UNITED STATES PATENT AND TRADEMARK OFFICE

10/536,463

Office Action Summary	Application No. 10/536,463	Applicant(s) VENKATASUBRAMANIAN ET AL.	
	Examiner GOLAM MOWLA	Art Unit 1795

DETAILED ACTION

Figure 1: Thermoelectric device of Venkatasubramanian using unipolar couple elements

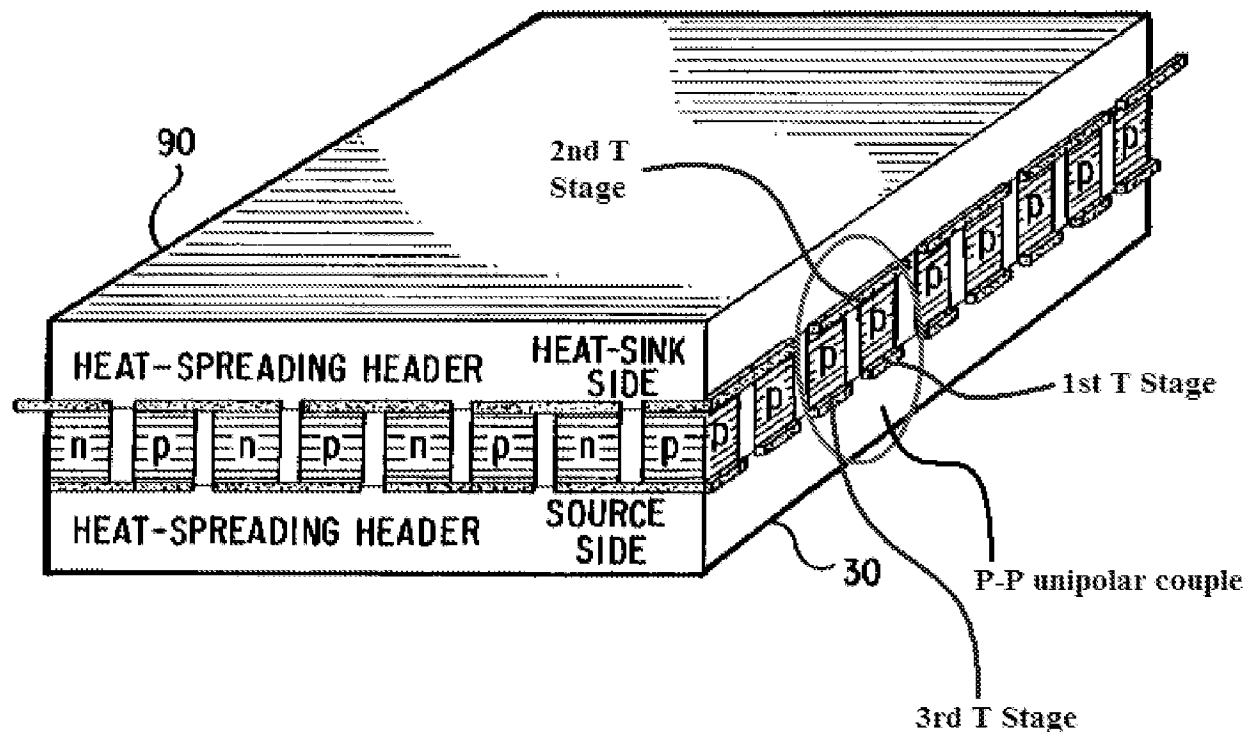
Regarding claim 1, Venkatasubramanian discloses a thermoelectric device (see figs. 6 and 9) comprising: at least one unipolar couple element having two legs of a same electrical conductivity type (two P-type semiconductor legs as shown in fig. 9; see fig. 1 as illustrated below); a first-temperature stage connected to one of said two legs; a second-temperature stage connected across said legs of the at least one unipolar

couple element; and a third-temperature stage connected to the other of said two legs (see 2:55-5:32) (see fig. 1 below).

Regarding claims 11-15, the reference further discloses at least one set of P-P unipolar bulk couple (see fig. 1 as shown above), one set of n-n unipolar bulk couple (see figs 6 and 7 which shows n-n unipolar couple on the left side of the TE device), and two independent legs of p or n).

Regarding claim 22, the reference further discloses that the first and second temperature stages are in split stages (see fig. above).
